Northwest Area Lift Station Improvements Great Hills Lift Station No.53

SP-2022-0537C

Variance Requests

Structural Site Plan

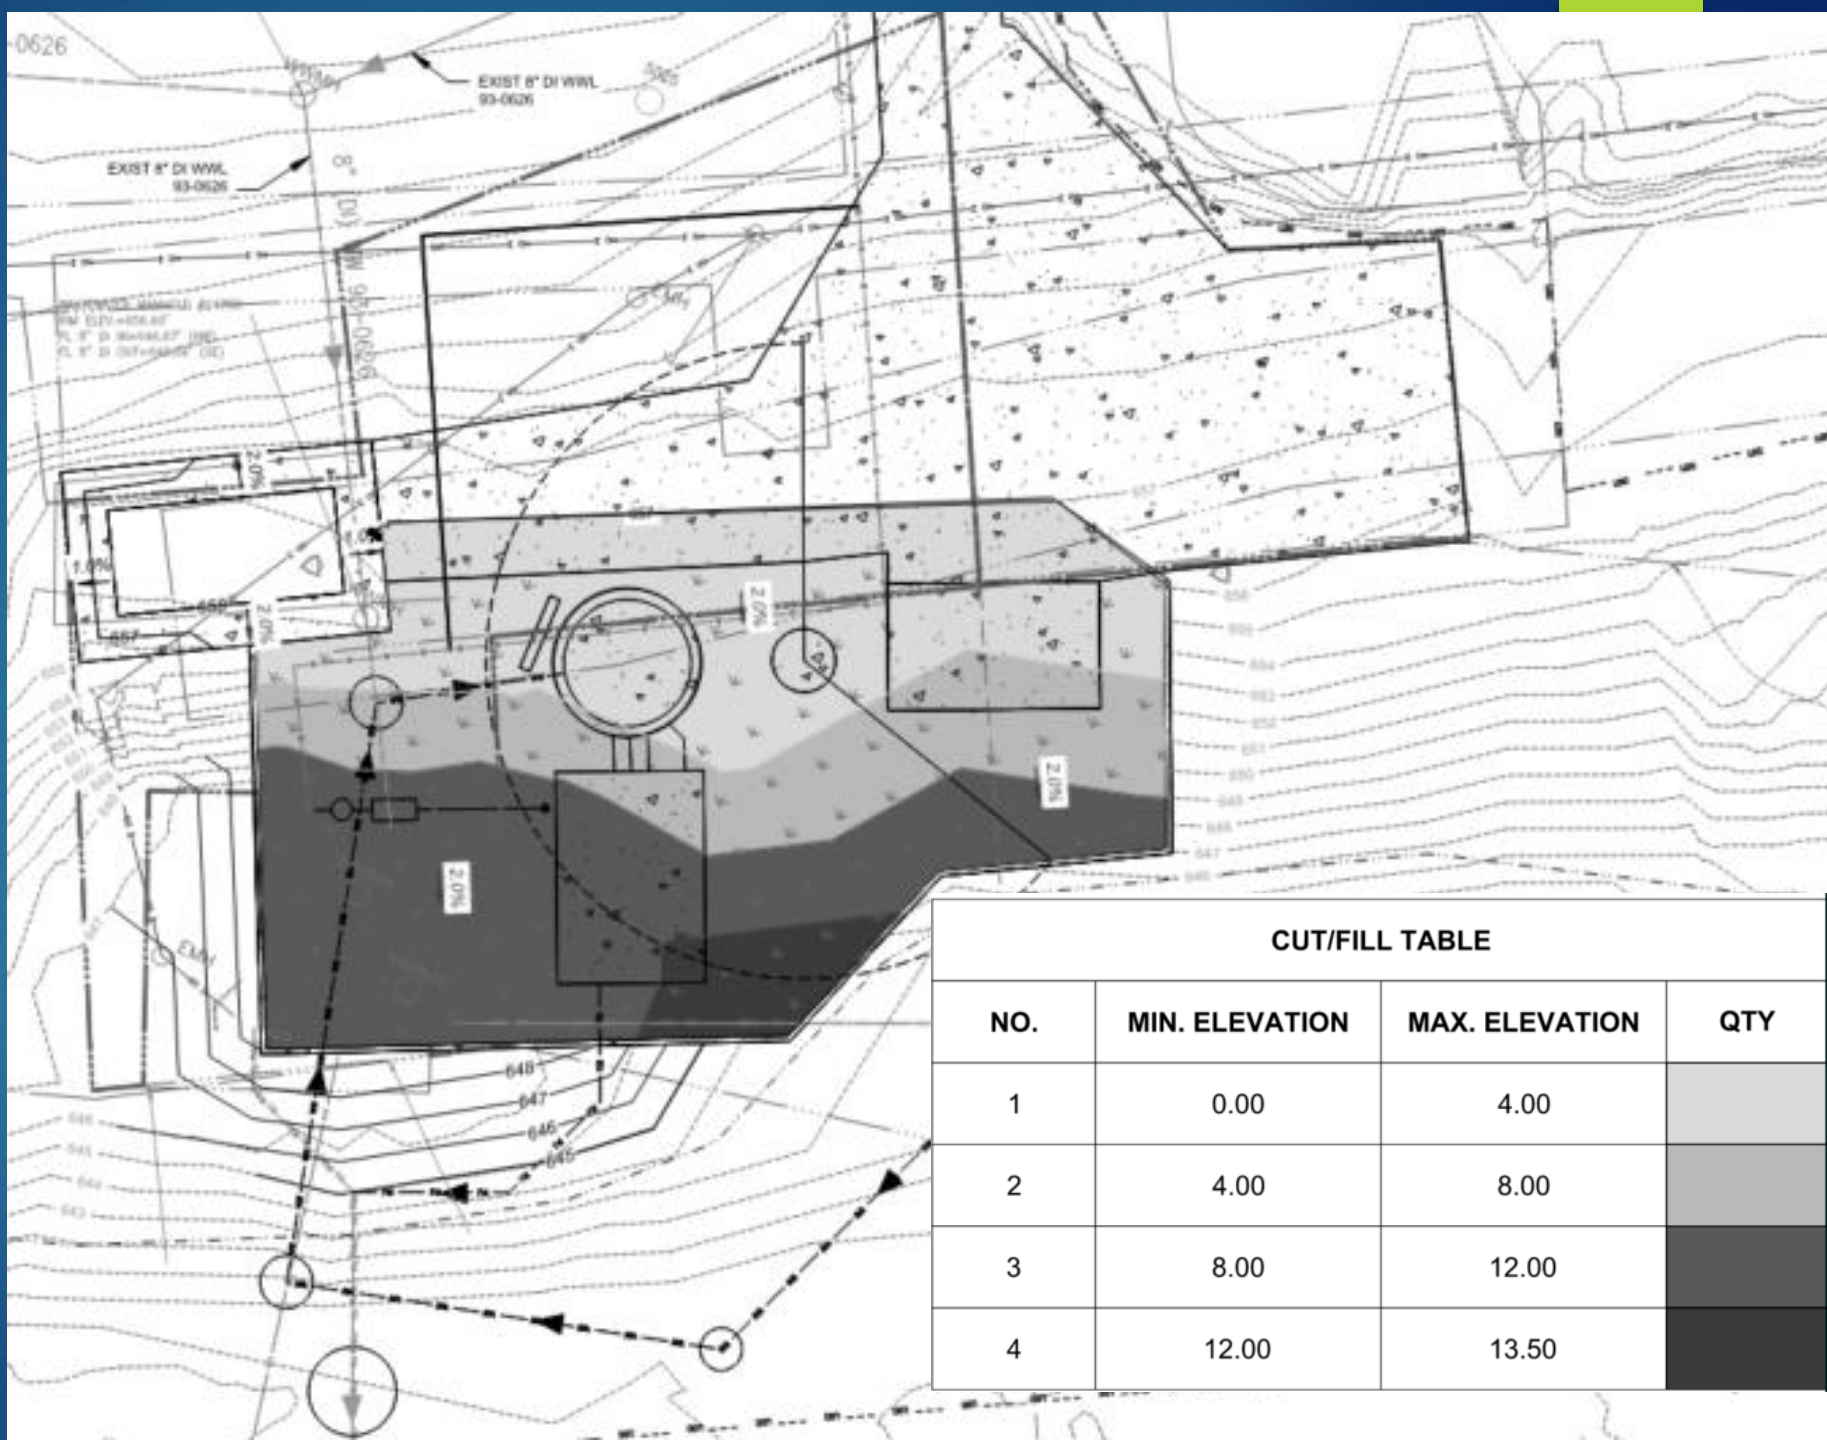
- The fill up to 14 feet is required to bring the elevation of the new lift station up to the level of the access drive

- **Provide structural containment of fill with a retaining wall**

Grading Exhibit

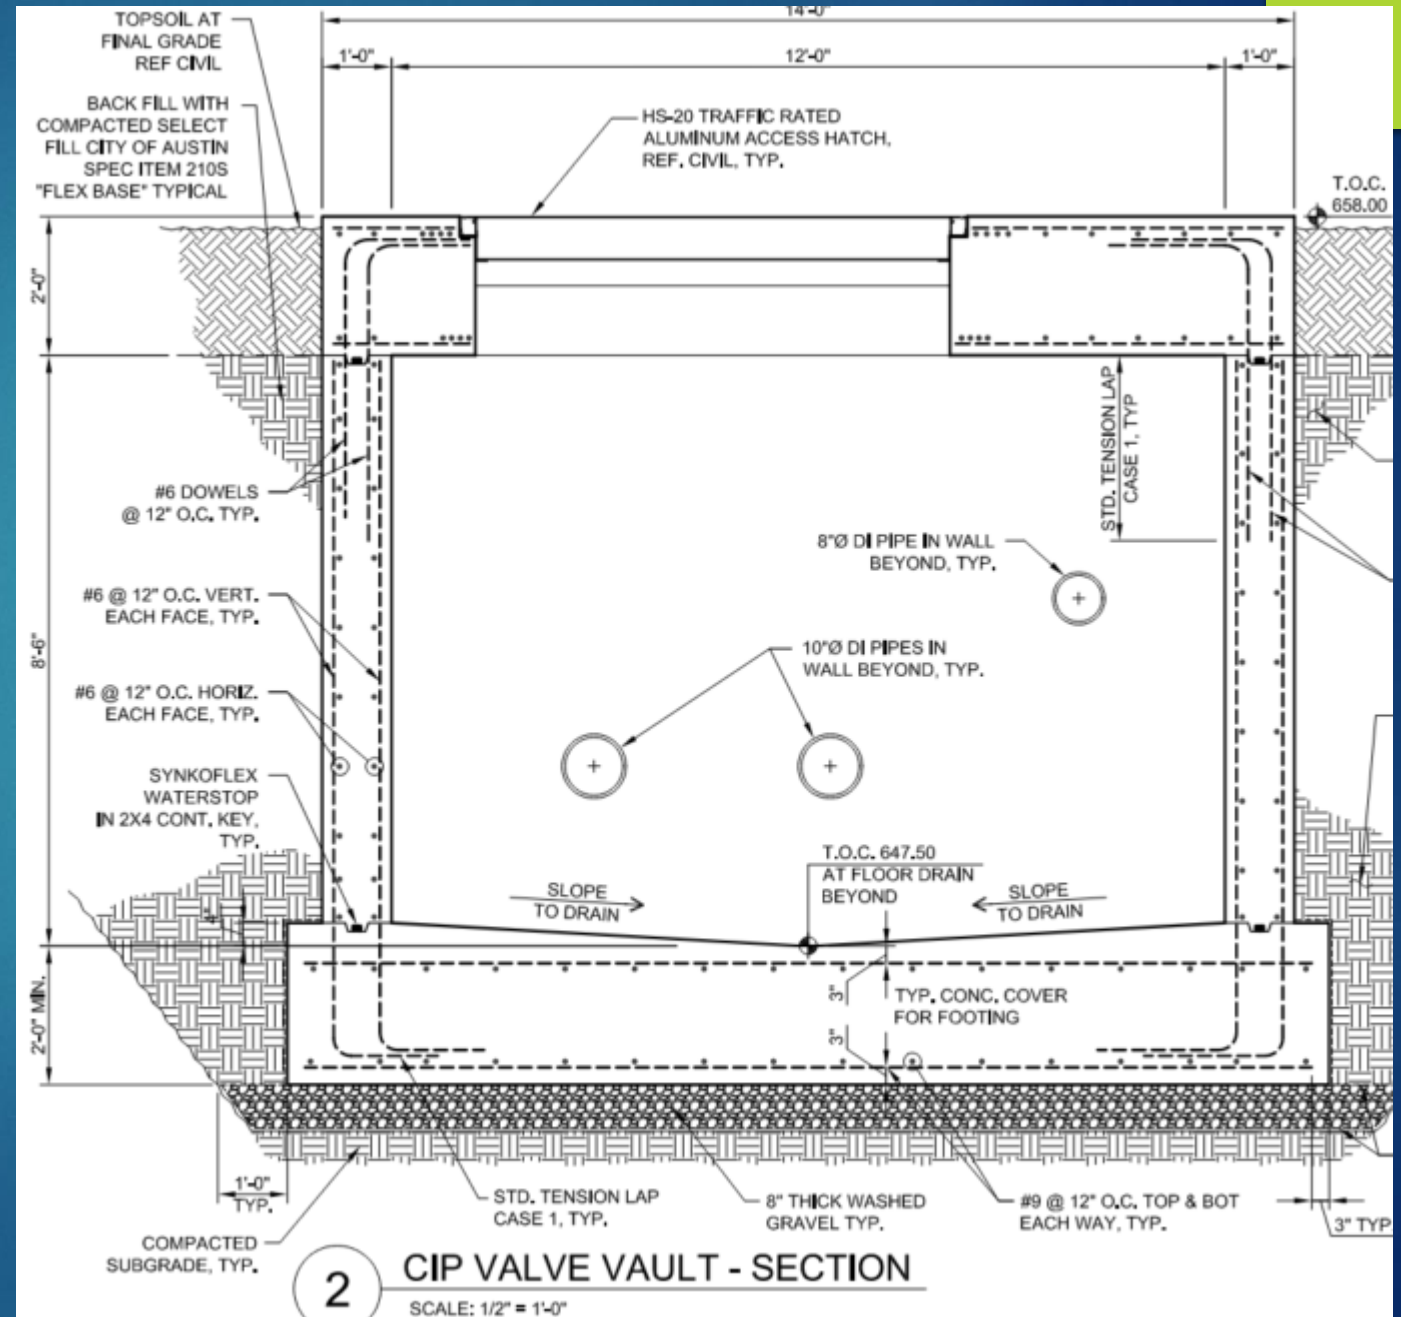
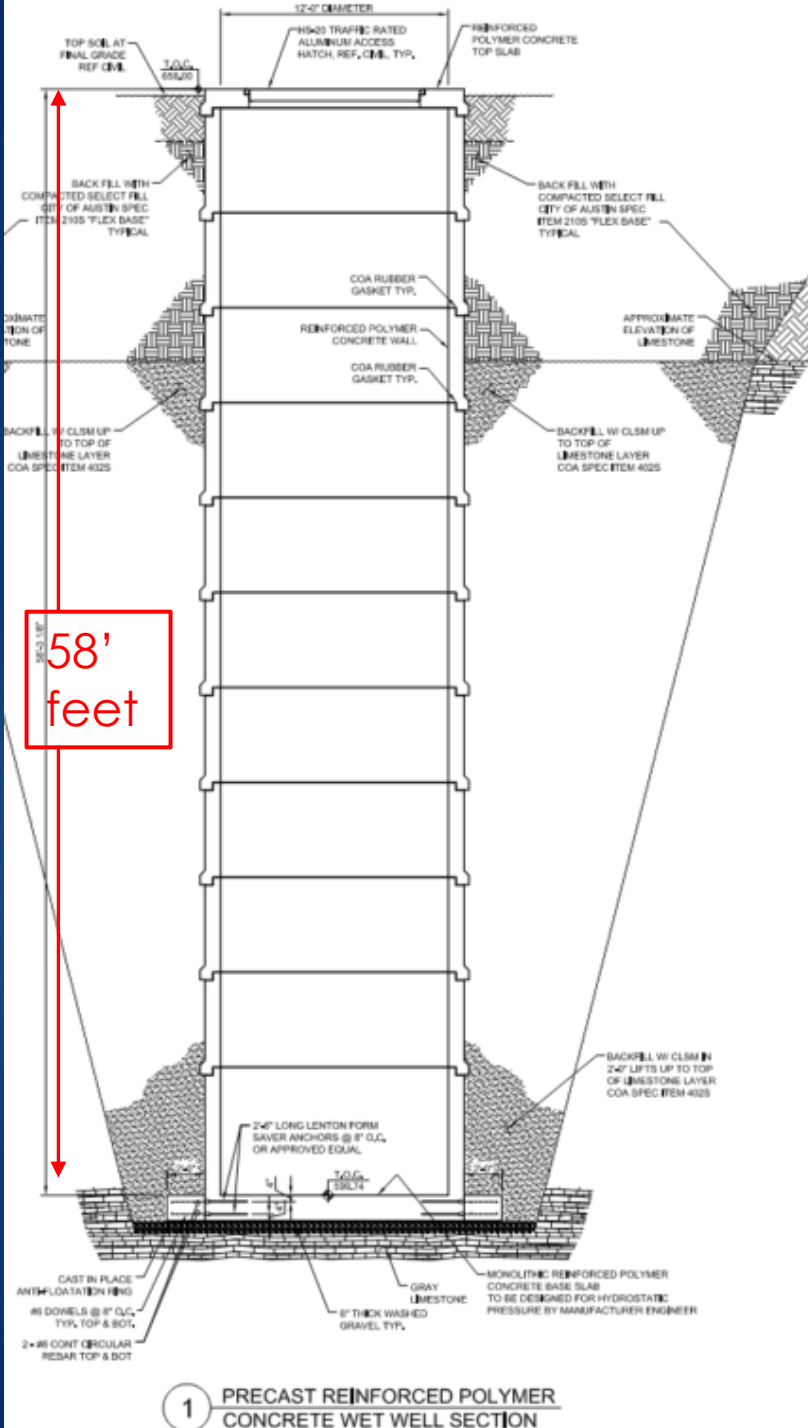
- ▶ To allow development in the CWQZ for a lift station per LDC 25-8-261
- ▶ To allow construction of a building on a slope with a gradient of more than 25% per LDC 25-8-302(A)(1)
- ▶ To allow fill up to 14 feet for construction of a lift station exceeding the 4-foot limitation per LDC 25-8-342

Staff recommends the variances, having determined that the required findings of fact have been met.
